**Proposed Development of Fernhill Park &
Gardens, Stepside, Co. Dublin with Works
within the Curtilage of the Protected
Structure (Fernhill House)
PC/PKS/01/17**

Fernhill Park & Gardens,
Rosemont Entrance,
Enniskerry Road, Co. Dublin

Road Safety Audit Stage 1

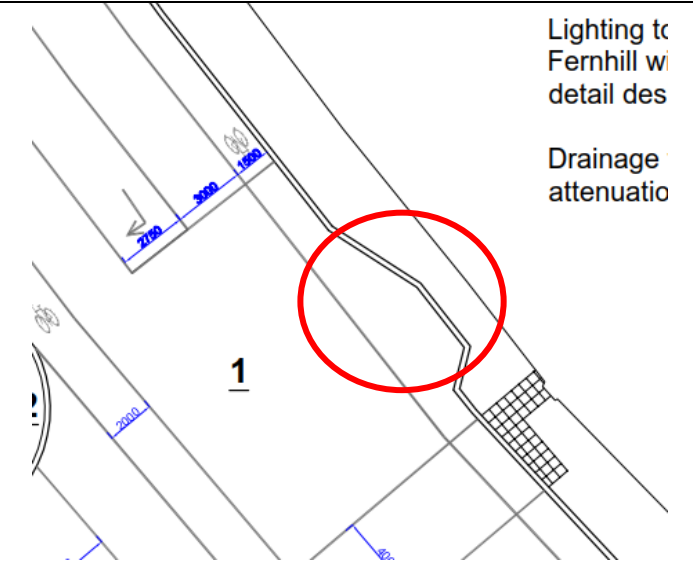
Problem 4.2.1:		
Location	Rosemont School Access Road	
Drawing	DRP-2315-06	
Summary	Limited visibility for motorists exiting the school on approach to the signalised junction	
Description		<p>There is a bend on the existing school road and forward visibility to the Enniskerry Road junction is reduced due to the boundary wall. No signage has been provided on the school access road to indicate to motorists exiting the school that a new signalised junction is ahead. The reduced forward visibility to the junction and lack of signage may result in some motorists approaching this junction at excessive speed resulting in collisions with pedestrians or rear end collisions.</p>
Recommendation:		
		<p>To improve awareness of the new junction, appropriate signage should be provided on the access road for vehicles exiting the school to indicate a signalised junction is ahead.</p>

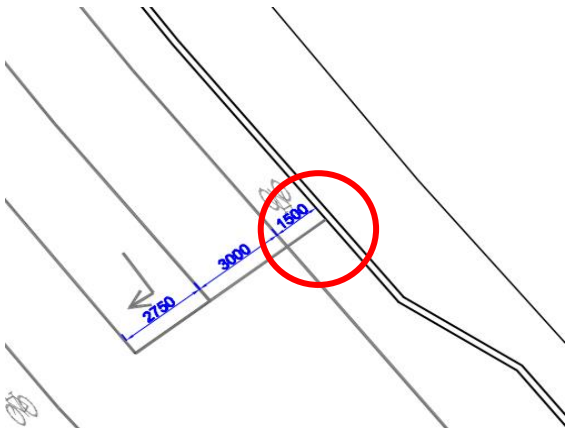
Problem 4.2.2:		
Location	Access road to park entrance	
Drawing	DRP-2315-06	
Summary	Steep gradient on access road to priority junction	
Description		
<p>From the site visit, the existing gradient of the park access road on approach to the priority junction appears to be steep. There is a risk of vehicles approaching the priority junction at speed; which may result in a collision with pedestrians crossing the priority raised crossing.</p>		
Recommendation:		
<p>Clarification should be provided on the gradient of this road on approach to the junction. The gradient on the immediate approach to the junction should be gentle. Anti-skid surfacing should be provided on the approach to the junction to improve motorist's control of their vehicles in all weather conditions.</p>		
Problem 4.2.3:		
Location	Signalised Junction

Drawing	DRP-2315-06	
Summary	No tracking provided for large vehicles through the junction	
Description		
<p>No auto-tracking is provided for large vehicles turning left from the Enniskerry Road NB into the access road for the school and park. If a coach/bus entering the school grounds does not have sufficient room to manoeuvre the left turn, the vehicle may overrun the stop line at the access road, which could result in a collision with motorists in the opposing lanes.</p>		
Recommendation:		
<p>Tracking of the largest anticipated vehicle should be provided in order to make sure it does not overrun the stop line at the access road.</p>

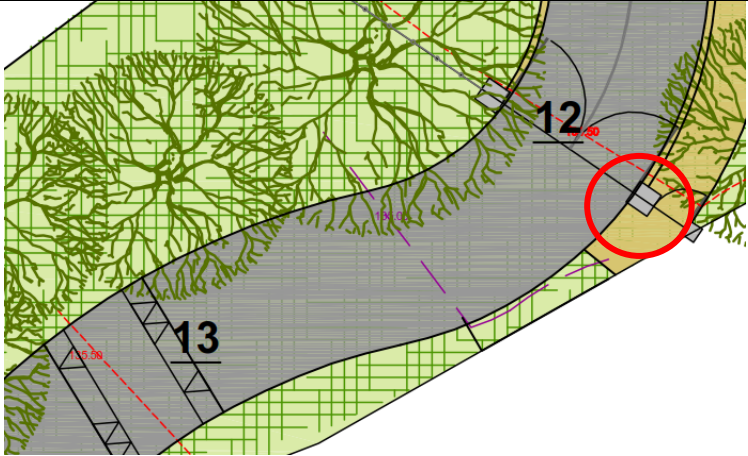
Problem 4.3.1:		
Location	School Access/Park Access Junction	
Drawing	DRP-2315-06	
Summary	STOP line located on pedestrian crossing	
Description		
<p>The STOP line for the side road is located on the pedestrian crossing. The STOP line is not provided at the first point of conflict with pedestrians. The location of this stop line could lead motorists to mount the crossing at speed, unaware of pedestrians, potentially causing a collision.</p>		
Recommendation:		
<p>The proposed crossing is as per Design Manual for Urban Roads and Streets (DMURS) guidance; however, the National Cycle Manual recommends a two stage approach for vehicles. For the 1st stage, motorists stop at a setback stop line location before the raised crossing to allow pedestrians to cross. In the 2nd stage, motorists proceed on to the crossing to the junction at a slow speed, giving time to see pedestrians and cyclists approaching the junction. This two stage approach should be incorporated at this crossing location with the stop set back before the raised crossing.</p>

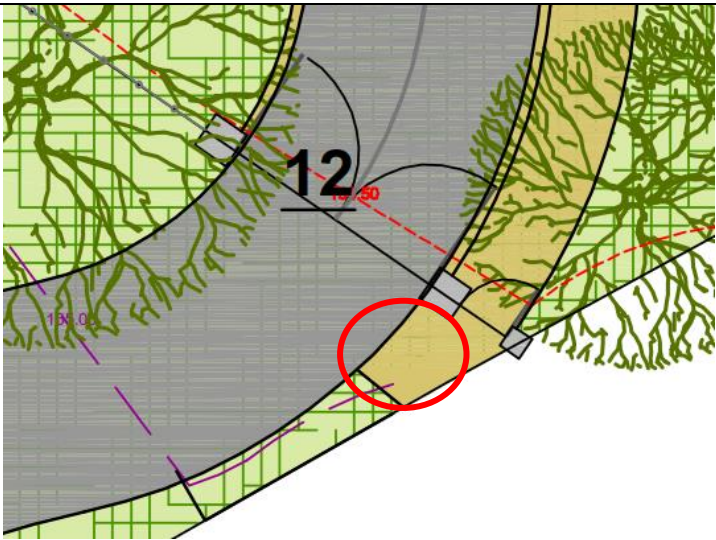
Problem 4.3.2:		
Location	Enniskerry Road Northbound	
Drawing	DRP-2315-06	
Summary	No stop line provided for cyclists	
Description		
<p>No stop line is provided at the signalised junction for cyclists travelling northbound in the cycle lane. Cyclists may fail to stop at the junction resulting in collisions with pedestrians or vehicles.</p>		
Recommendation:		
<p>A cycle stop line should be provided at this location.</p>
